VARIANCE APPLICATION

RE: BROWNS POND ~ LOT 2
10 West Severn Ridge Road
Annapolis MD, 21409
Variance Application

CONFIRMATION OF PRE-FILE MEETING

Subject: Browns Pond, Lot 2 – 10 West Severn Ridge Road
Pre-file

VARIANCE PLAN
BROWNS POND ~ LOT 2
10 WEST SEVERN RIDGE ROAD, ANNAPOLIS, MD 21409
TAX ACCT. NO. 03-000-02175960 ~ PERC NO. T02050024
TAX MAP 0046 GRID 0007 PARCEL 0021 DISTRICT 3RD
ANNE ARUNDEL COUNTY, MARYLAND

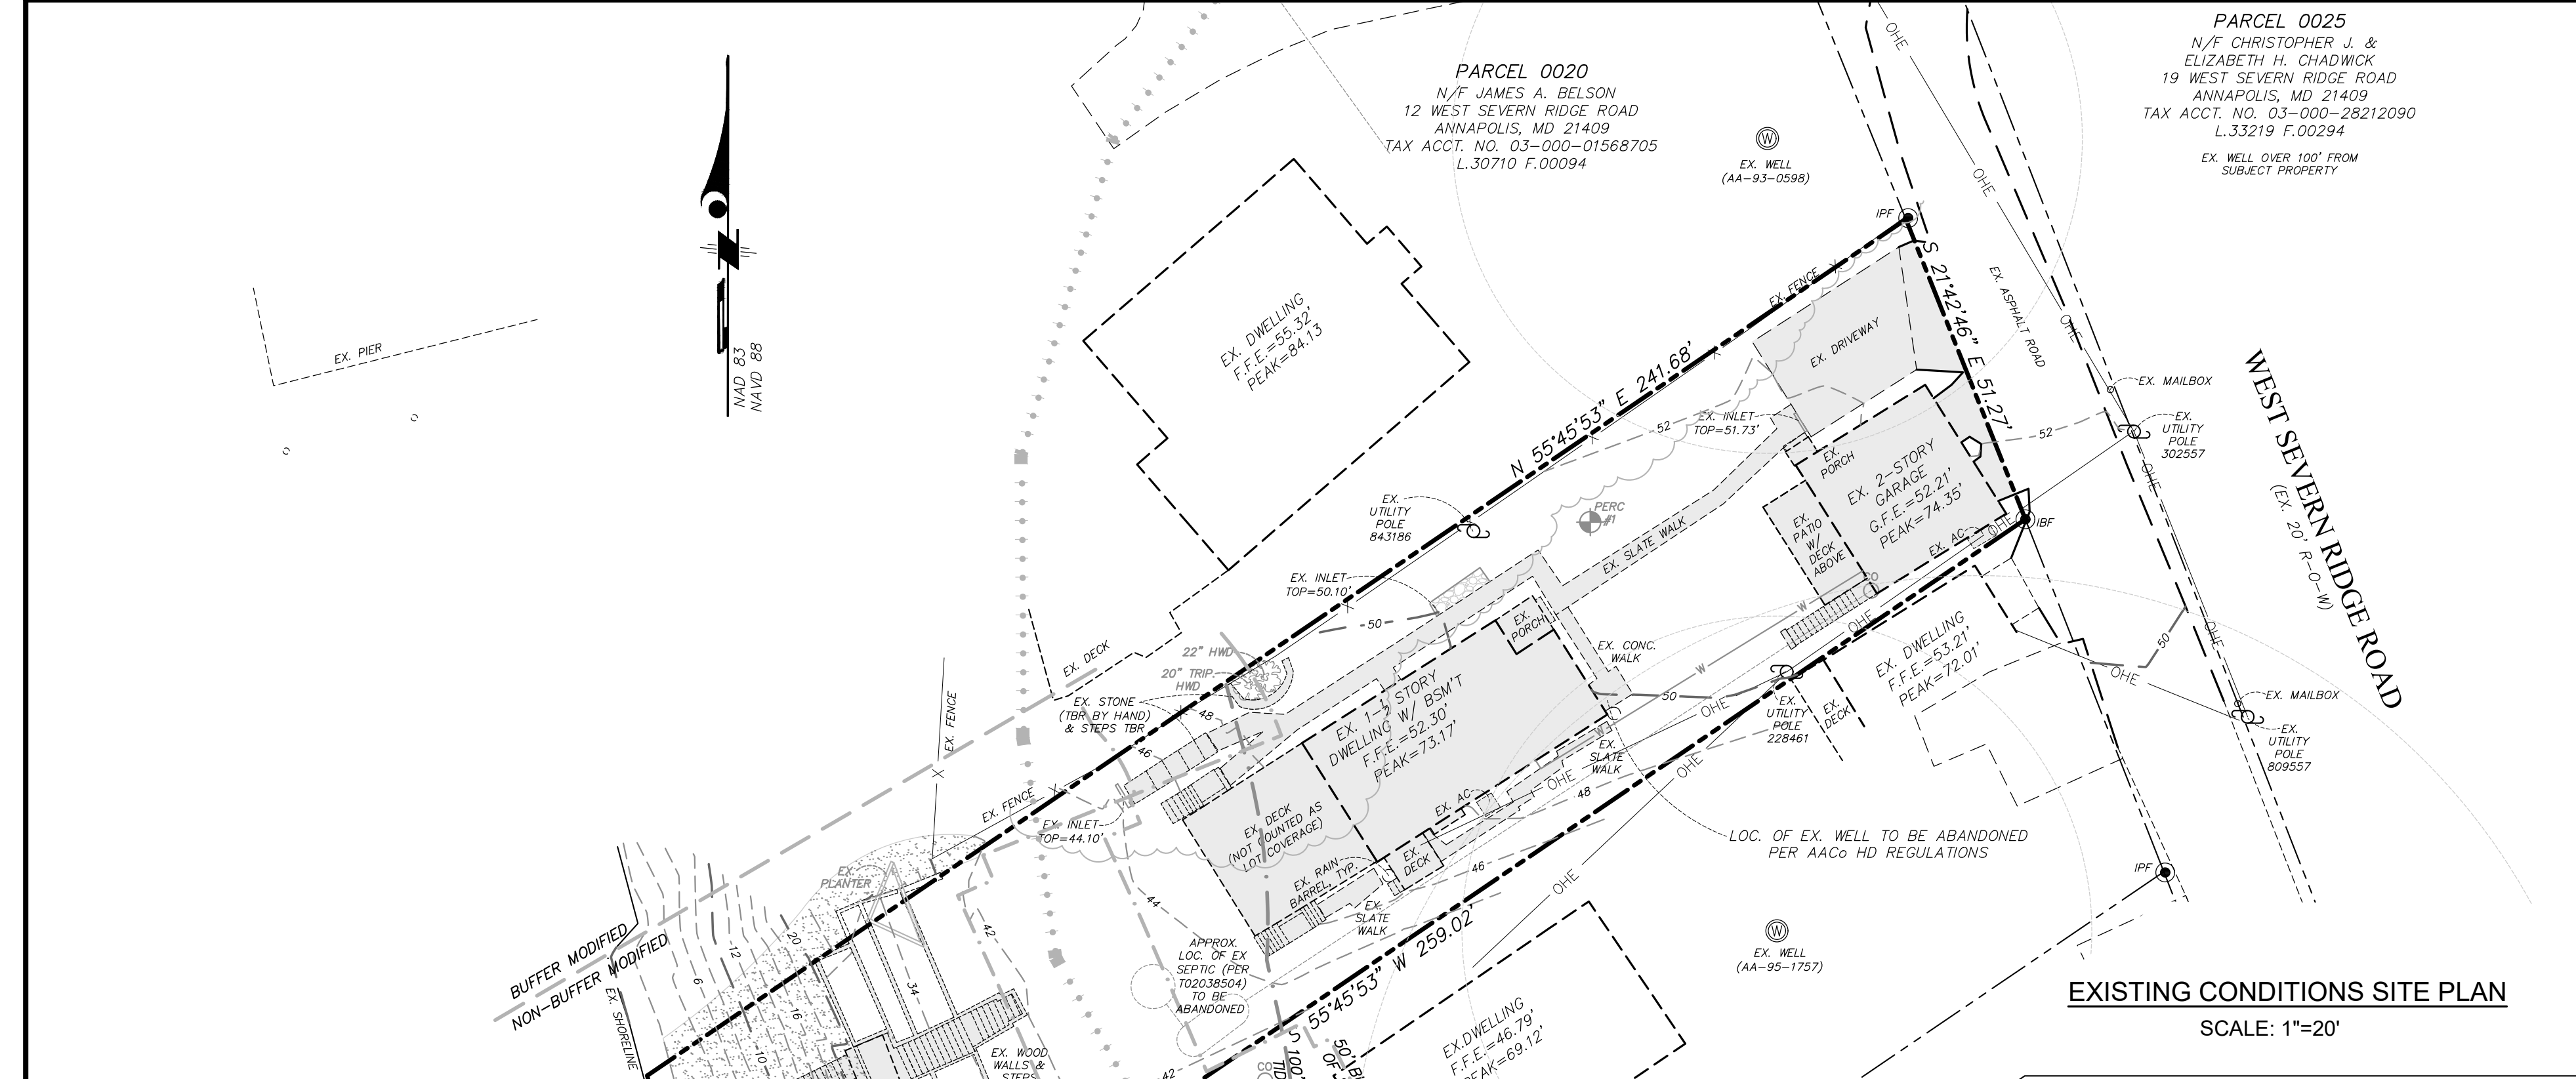
The **Zoning Administration Section** advises that Section 18-2-301(f) applies to dwelling additions only and does not apply to new dwellings on undersized lots. Therefore, a zoning setback variance is also required. The variance site plan is confusing, as it is difficult to determine what the various rectangular areas represent. The site plan should clearly label any porches and decks or any other dwelling sections that have different heights/stories. The distances to the property lines, particularly those requiring a variance, must be labeled. The applicants are reminded that, in order for the Administrative Hearing Officer to grant approval of the variances, the proposal must meet all of the Critical Area variance standards provided under Section 18-16-305.

The **Development Division's Critical Area Team** commented that the site plan needs to be better labeled and the justification revised to describe exactly what development activity is taking place within the buffer. The Team does not object to the replacement of the deck within the buffer as long as it is in-kind or smaller than the existing deck; however, the site plan needs to clarify what is existing vs. proposed.

It is not clear if disturbances to the steep slopes and/or its buffer is proposed with this application.

A separate existing and proposed maps/plans are required to discern the existing structures, proposed structures, structures to remain, structures to be removed, etc. This also need to be discussed in the SWM report narrative. No narrative was provided. As part of the ESD considerations, the proposed site layout selection must demonstrate minimization efforts. Since the lot is substandard in size under existing conditions, setbacks are not met, and the ability to meet the SWM regulations for ESDv are not demonstrated, imperviousness should be minimized and under no circumstance should it be intensified under the proposed conditions.

The information provided in the ESDv computations, ie. Drainage area numbers, roof numbers, DA numbers do not correspond to the information on the plan. We are unable to verify or match the computations with the plans.

Drainage area maps were not provided for the proposed SWM practices.

The site outfall was not identified on the plan. An outfall statement is required. A condition assessment of the steep slopes by a geotechnical engineer is required as part of the site outfall analysis. Include a condition assessment report and photographs. The soil edibility index must be added to the plan. Highly and potentially highly erodible soils must be considered for enhanced stabilization during construction.

Rain handler is proposed for the existing patio w/deck above. This is not considered alternative surface ESD. Rather this is non rooftop disconnection nonstructural practice. The contributory roof and the disconnection areas were not delineated on the plan to verify that the MDE disconnection criteria is met.

A SWM filter tank was proposed. Proprietorship SWM devices are not permitted for single family residential dwellings.

It is not clear how the existing driveway and garage are treated. Disconnection areas must be highlighted clearly and may not overlap, intersect with impervious surfaces, or include excessive contributory pervious or impervious lengths of flow beyond what is permitted by MDE.

Setback requirements: The submitted plan must show clearly with dimensions the setback provided from the proposed Stormwater practices to the proposed house, the adjacent property lines, the top of the 15% steep slope, the proposed well, etc.
